# Westfield Warringah Mall

Proposed modification under Section 96(2) to DA  
2008/1742

November 2014

FIGURE 1 – EXTRACT FROM PLAN SHOWING PROPOSED ENLARGEMENT OF EXISTING BOX CULVERTS UNDER CONDAMINE STREET

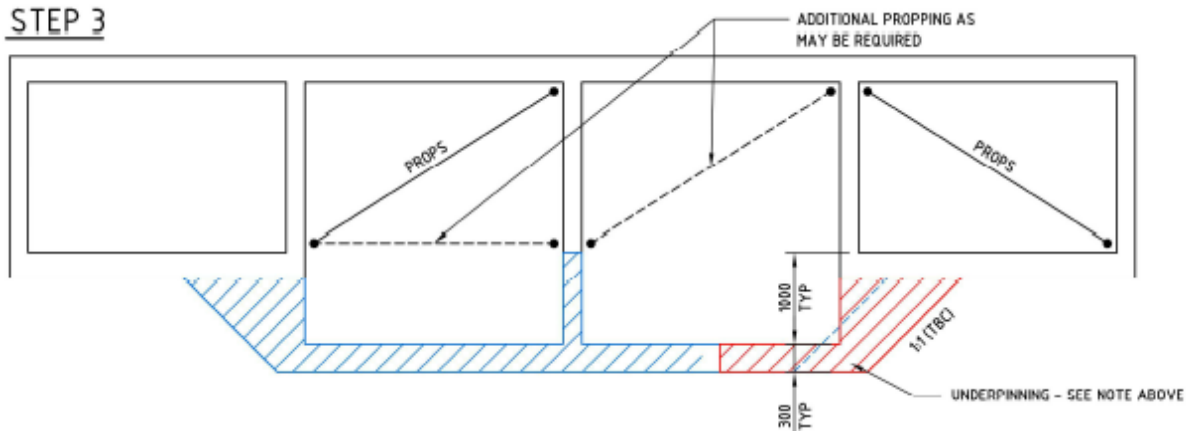
The amended concept design involves:

- The reconstruction of Chamber C6;
- The lowering of the invert levels of the two central box culverts by 1.0m together with the lowering of the apron slab upstream of the gross pollutant trap (GPT) downstream of Condamine Street.

The concept for the lowering of the two central box culverts is illustrated in the following plan extract and image.
